LOT 8002 BARINGA TERRACE HOMES

RFI ISSUE

SITE INTRODUCTION

PROJECT
LOT 8002 BARINGA DR
BARINGA BOULEVARD, AURA
CALOUNDRA WEST

DRAWING TITLE
SITE PLAN - CONTEXT

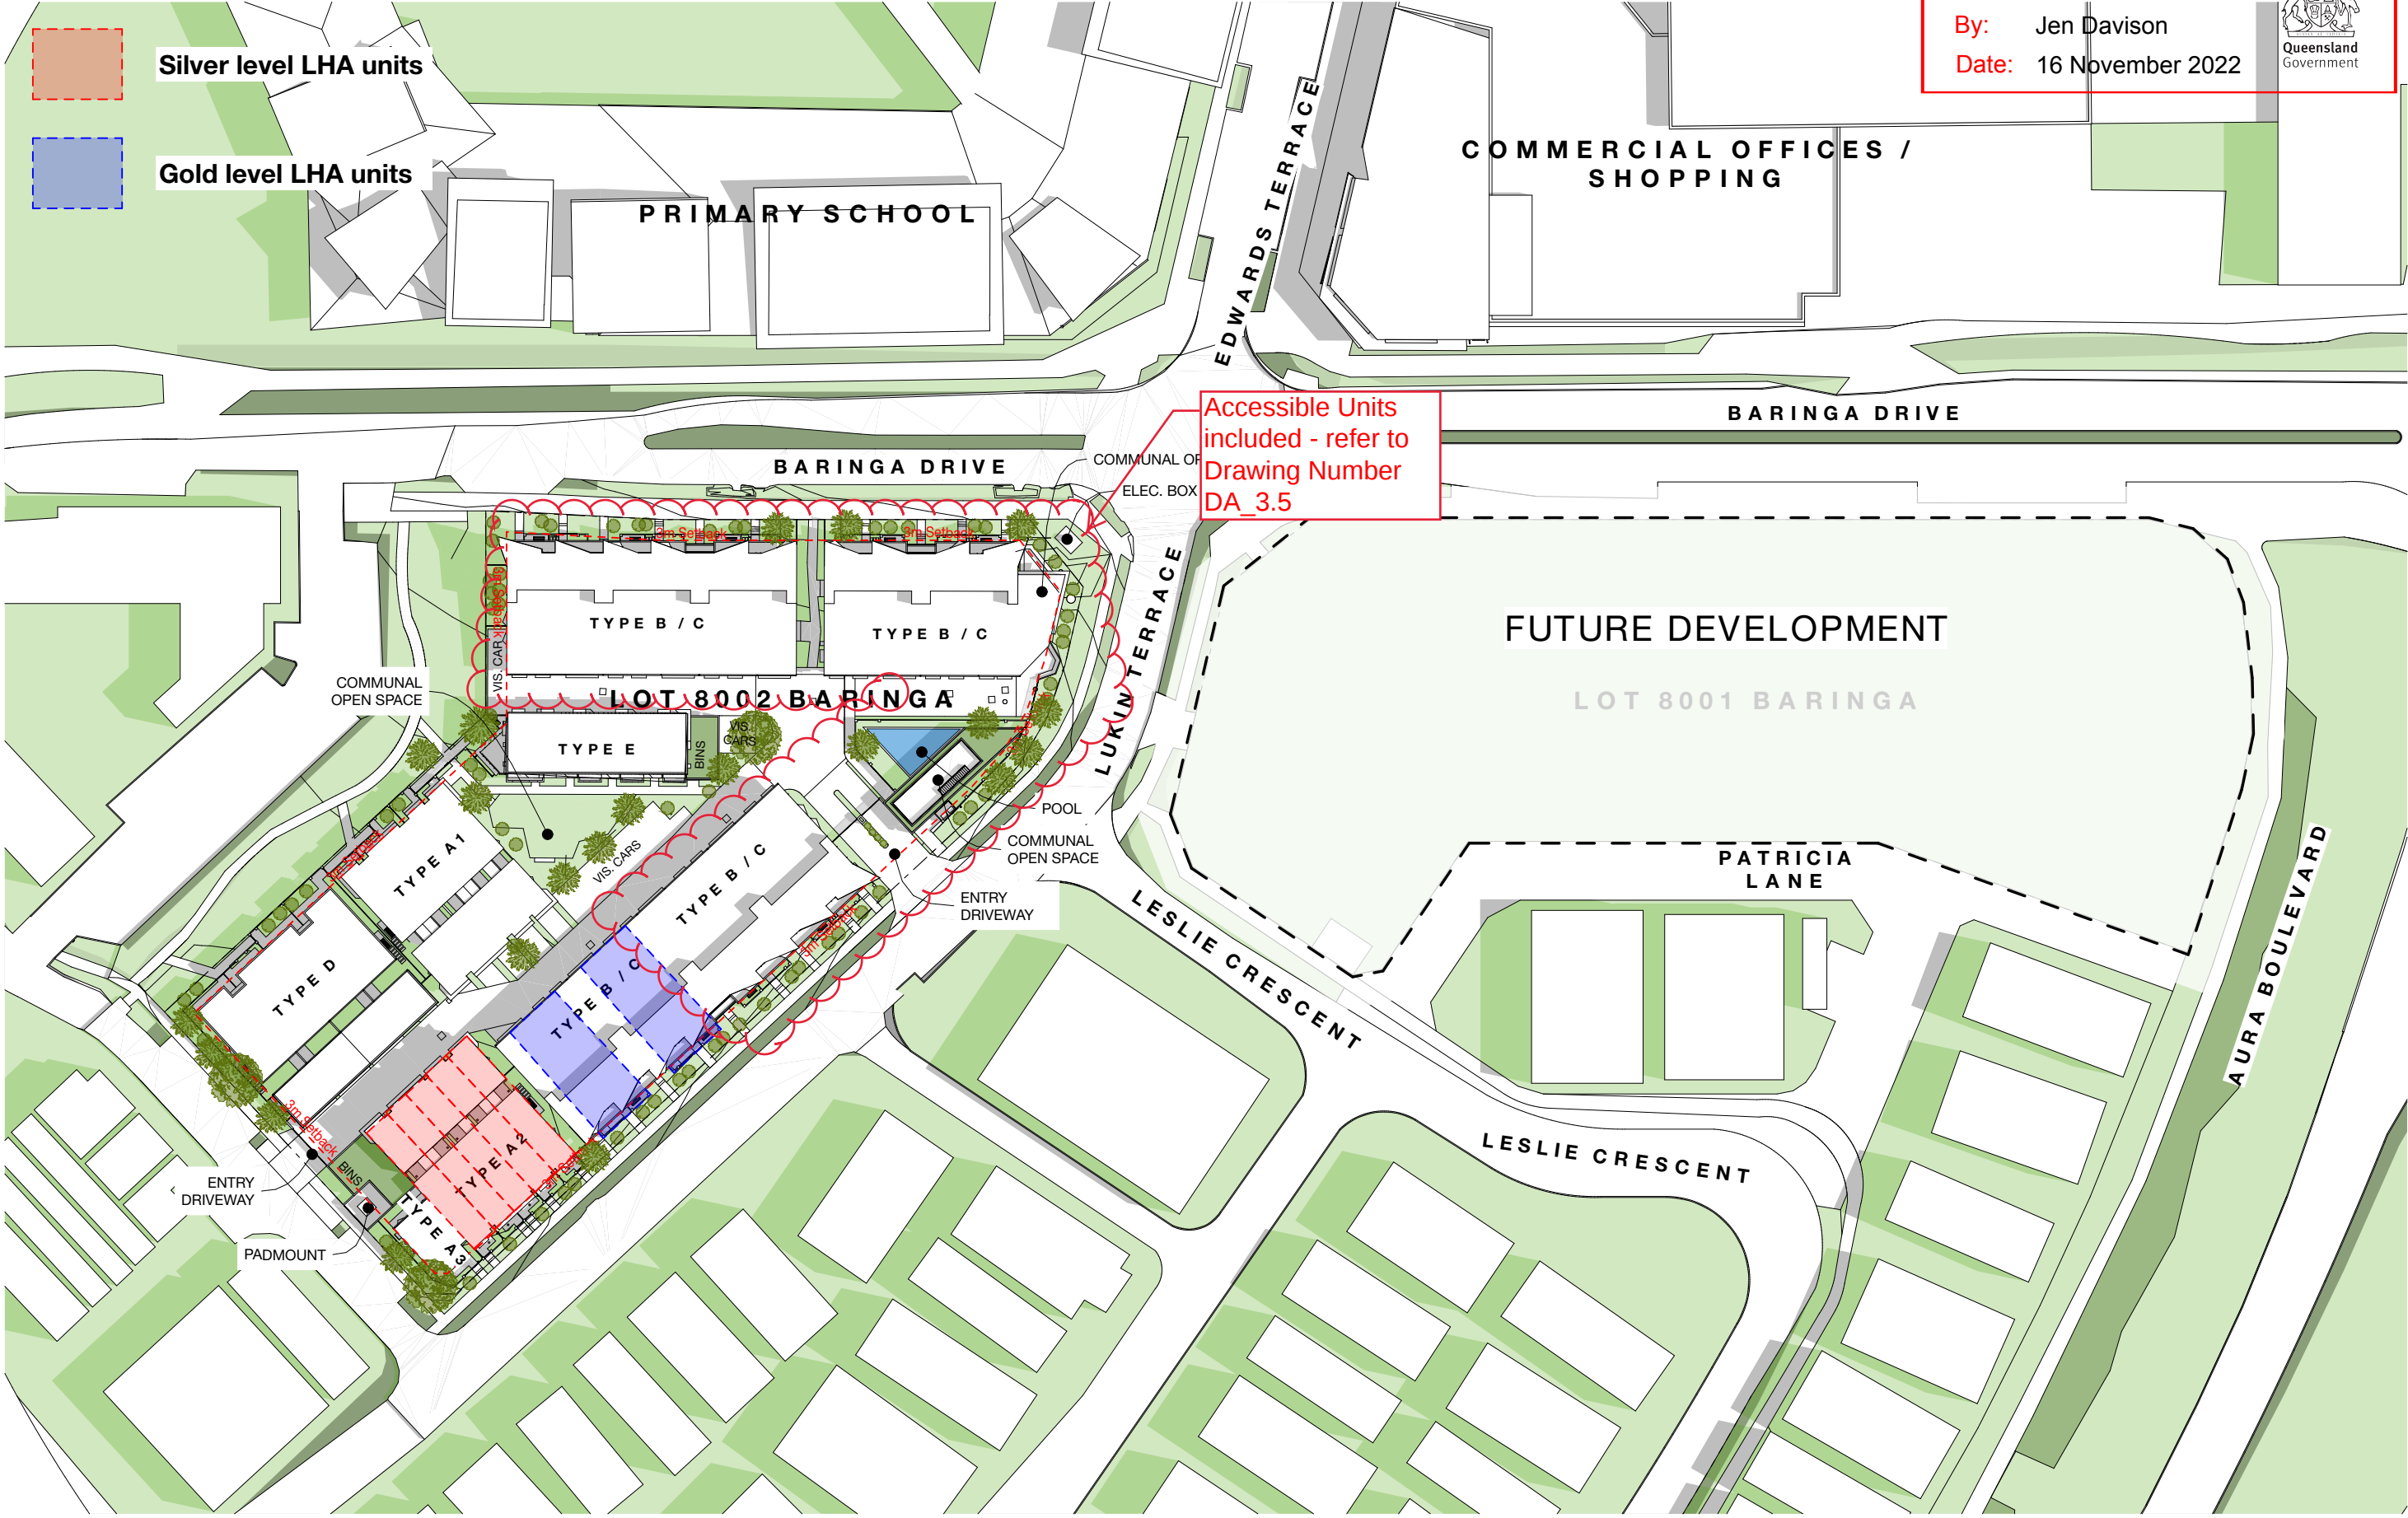
AMENDED IN RED

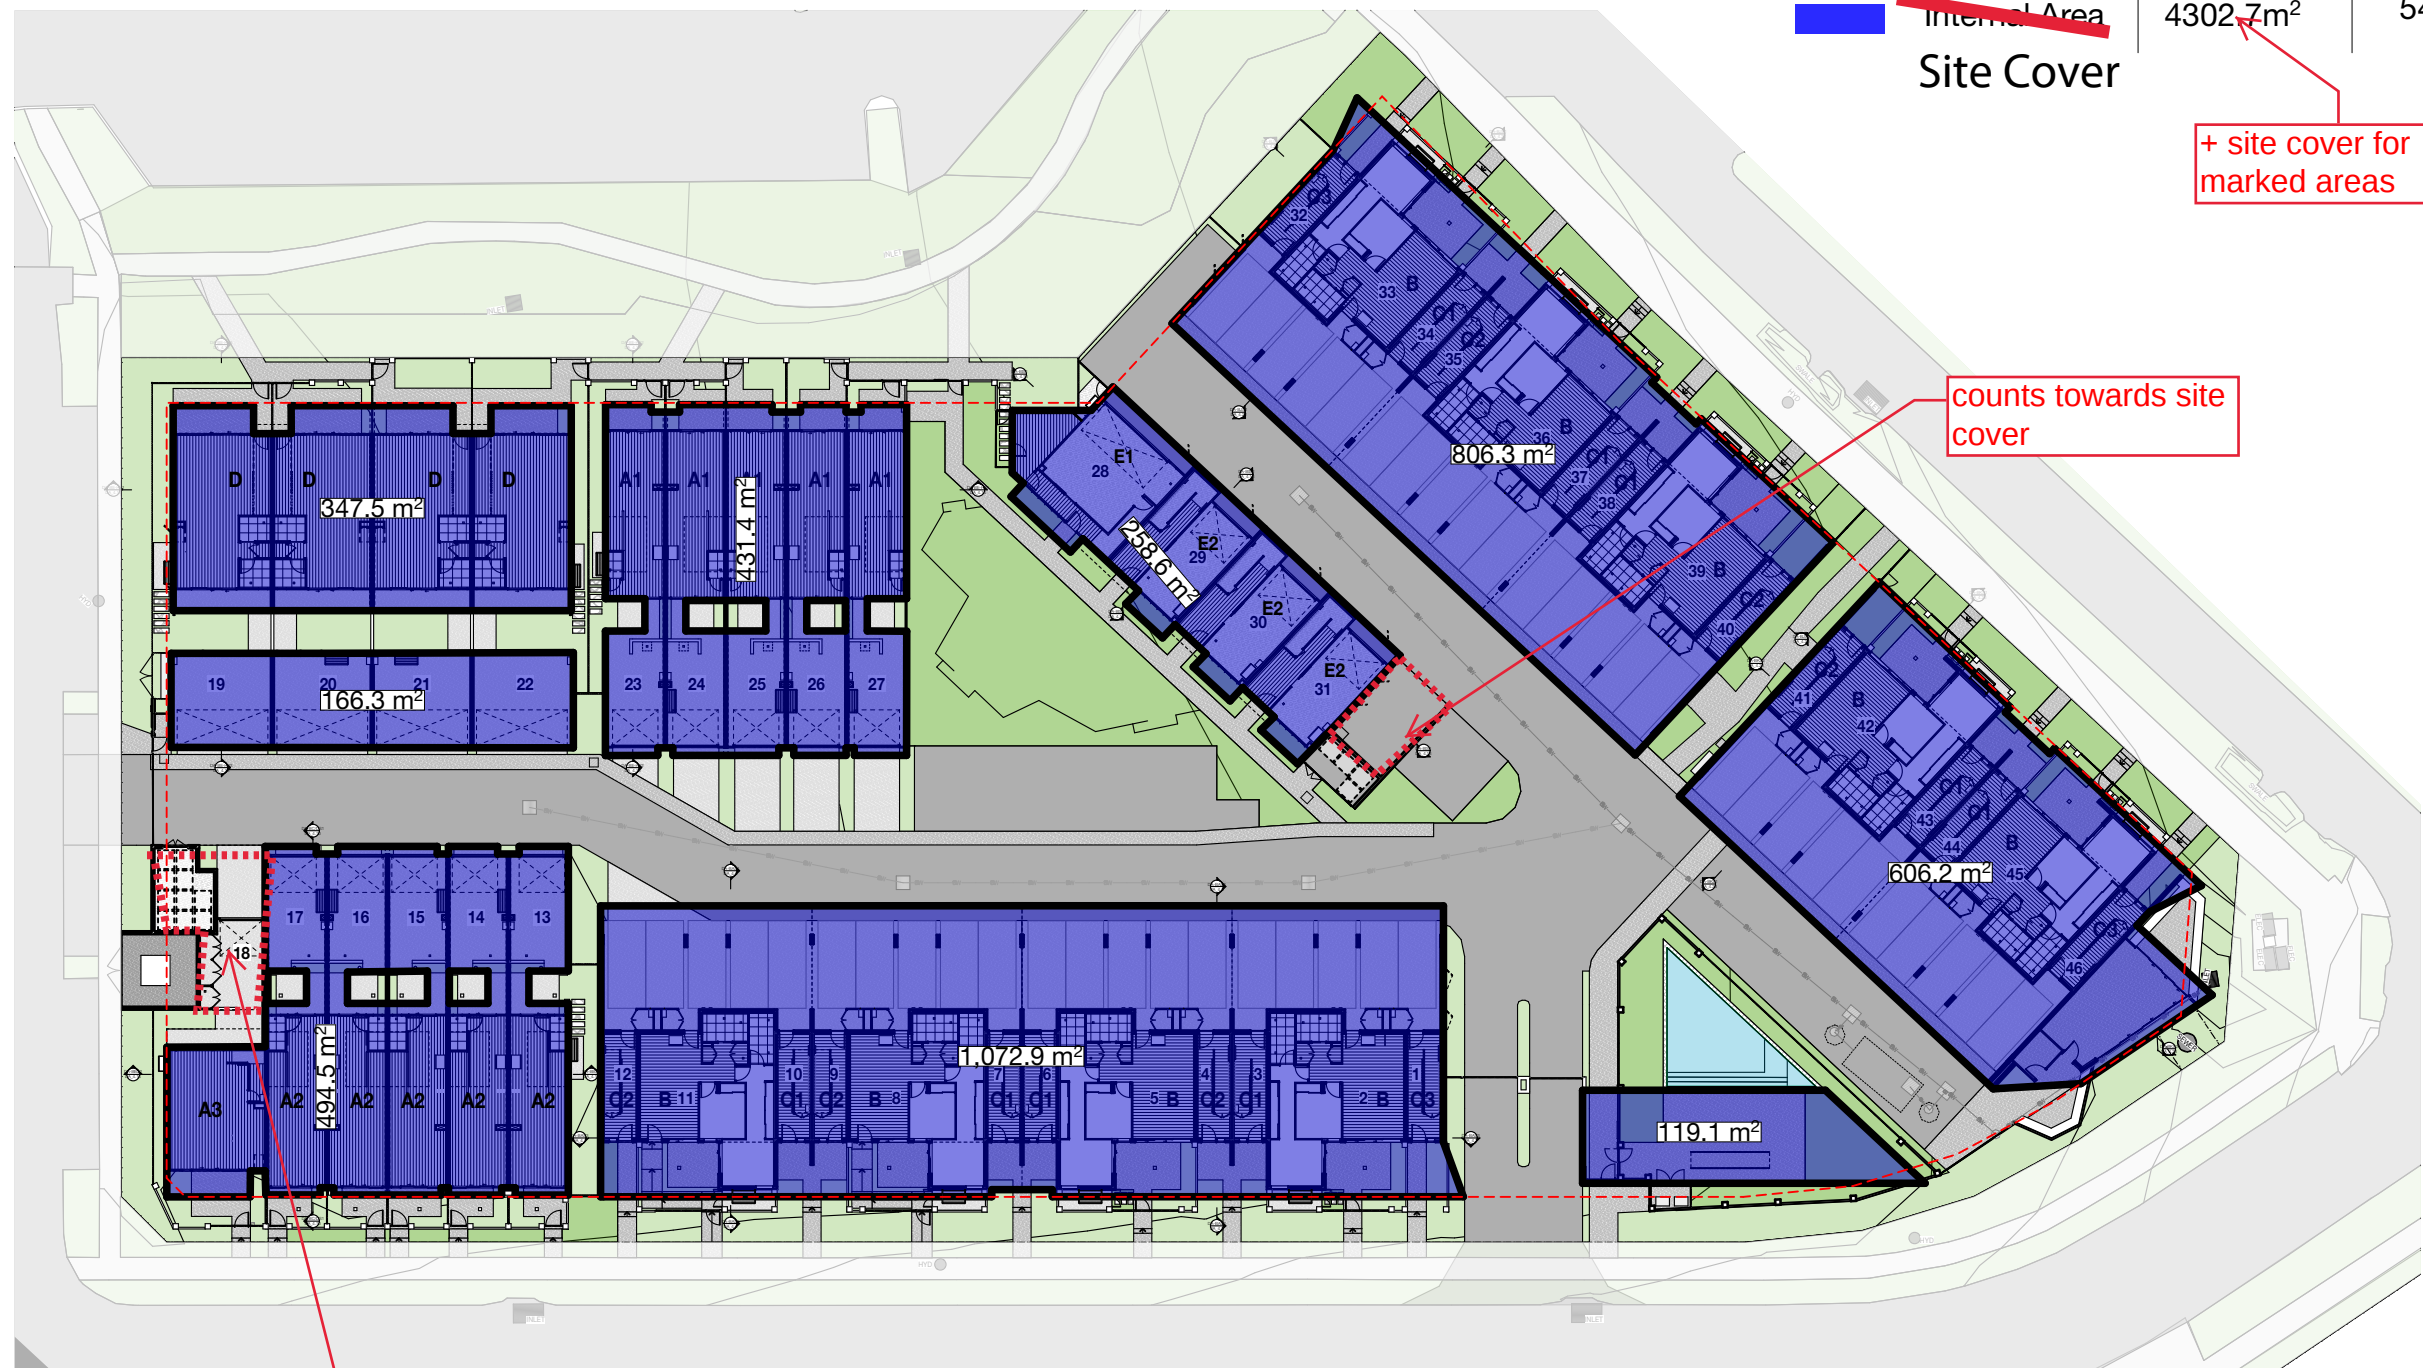
AMENDED IN RED

Internal Area Site Cover	4302.7m ²	54.5%
---	----------------------	-------

- counts towards site cover

counts towards site cover
